Land Transport Rule: Traffic Control Devices Amendment 2019

Land Transport Rule
Traffic Control Devices Amendment 2019
Rule 54002/2004/12

Schedule 1 Amendments to Schedule 1 of Land Transport Rule: Traffic Control Devices 2004

Schedule 2
New items inserted in Schedule 2 of Land Transport Rule: Traffic
Control Devices 2004

M2-3C: Cycle path or shared path crossing driveway.

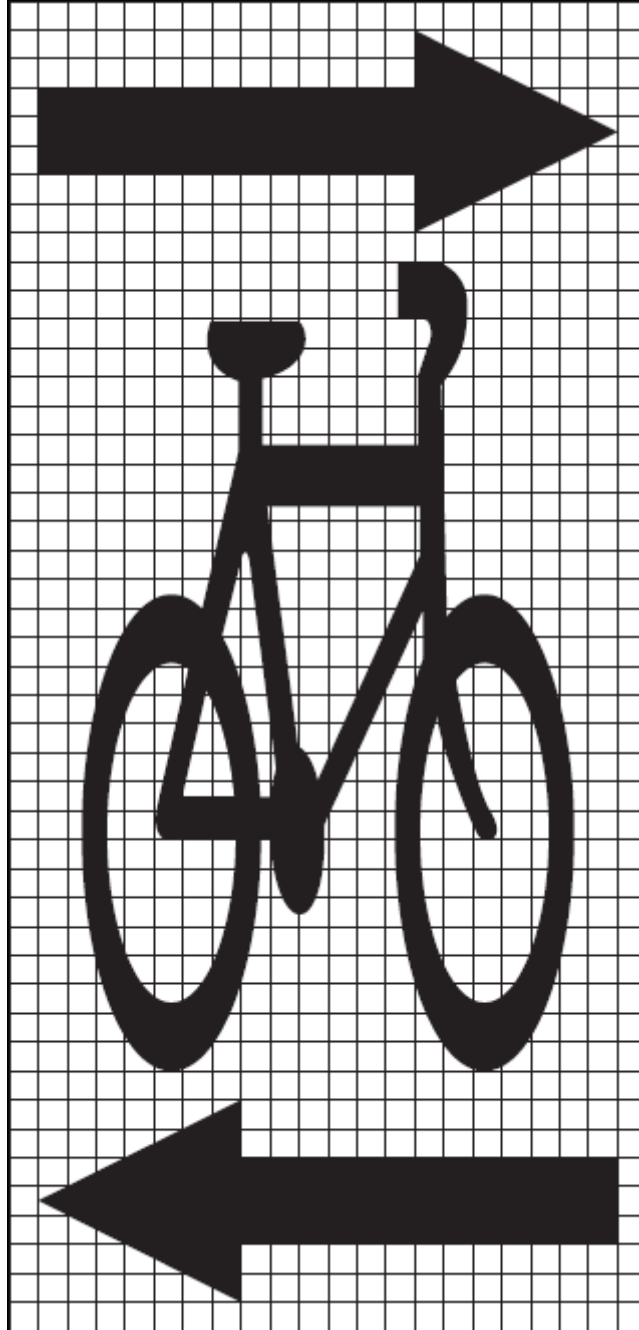
2.13(5) In *Schedule 2*, insert the items set out in *Schedule 2* of this Rule in their appropriate alphabetical order.

Note: for a one-way path, either arrow may be omitted and the cycle symbol may be reversed so that the remaining arrow and the cycle symbol indicate the direction of travel.

M2-3E: Alternative cycle symbol marking for shared paths

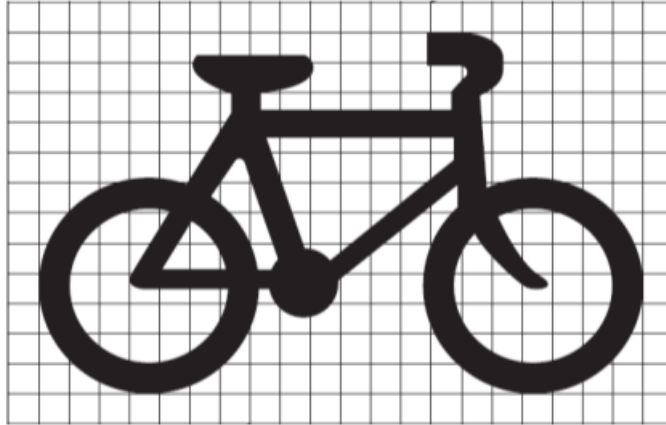
Note: for a one-way path, either arrow may be omitted and the cycle symbol may be reversed so that the remaining arrow and the cycle symbol indicate the direction of travel.
